City of St. Augustine

Historic Architectural Review Board

A G E N D A

Thursday, November 21, 2019 12:00 p.m.*

**Looking toward 170 Avenida Menendez,
Adjacent Property to the South with 5-1/2' H Masonry Stucco Covered Wall**

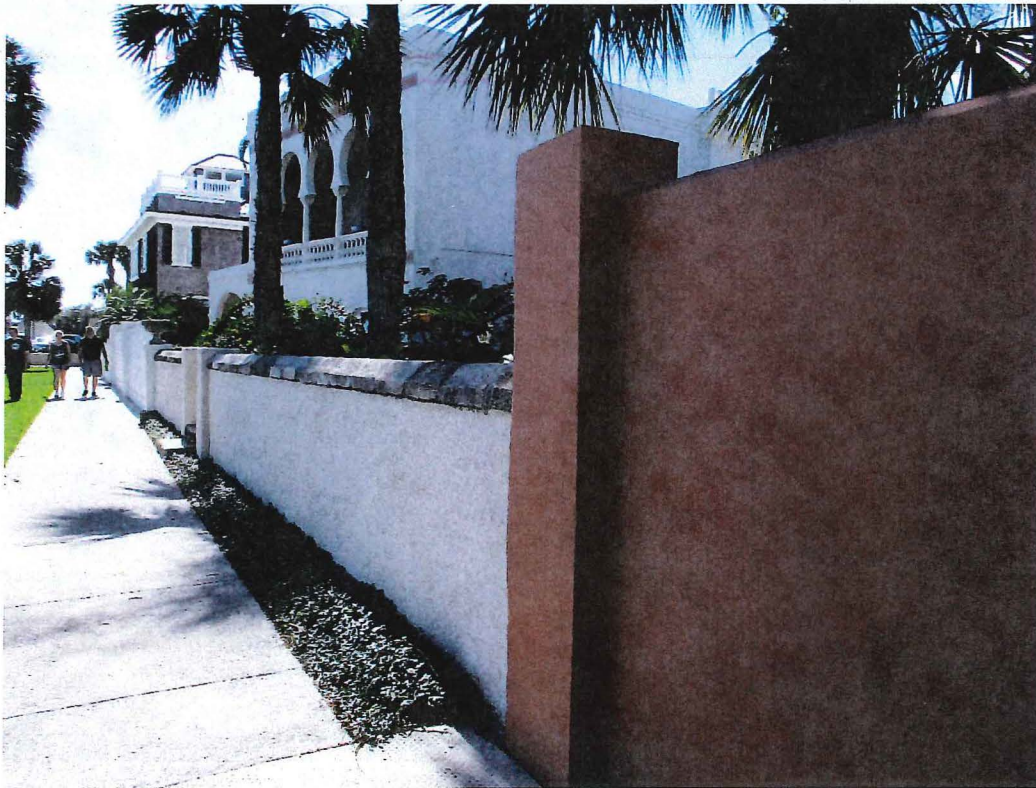
- the adjacent property to the south of the building (170 Avenida Menendez) has a wall measuring around 5-1/2' high from the ground
- COA2010-0103 approved a previous application to add new balcony railings that match the existing rail on the front porch. For this COA, the ornate cast iron fence proposed to be used as balcony railings looks to be from the late 19th century and has been the primary fence for some time. While the existing fence is more ornate than the house, it has been along the front of the property for some time and is just being relocated to another area of the house.

PROPOSED FRONT WALL ELEVATION

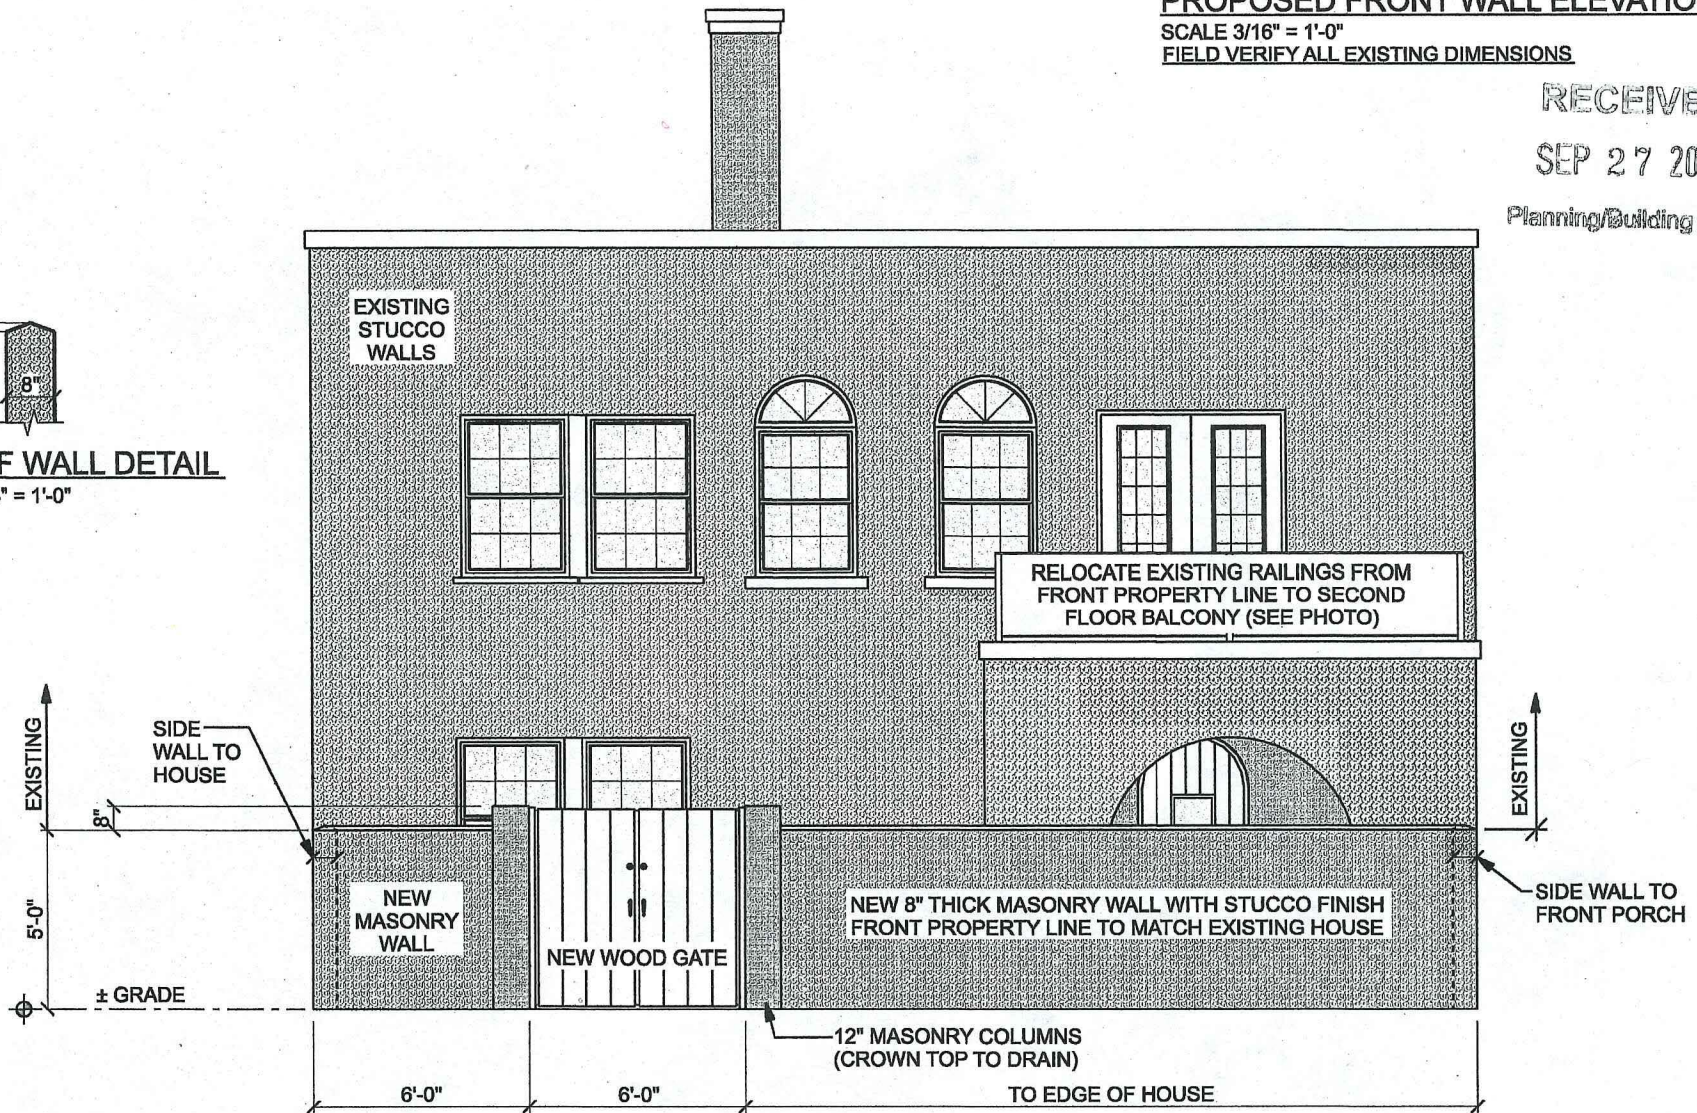
- This is a Mediterranean Revival style residential building and contributing to the St. Augustine Town Plan National Register District.
- Buildings along this streetfront have been mitigating for flooding damage in recent years including building new or higher property walls.
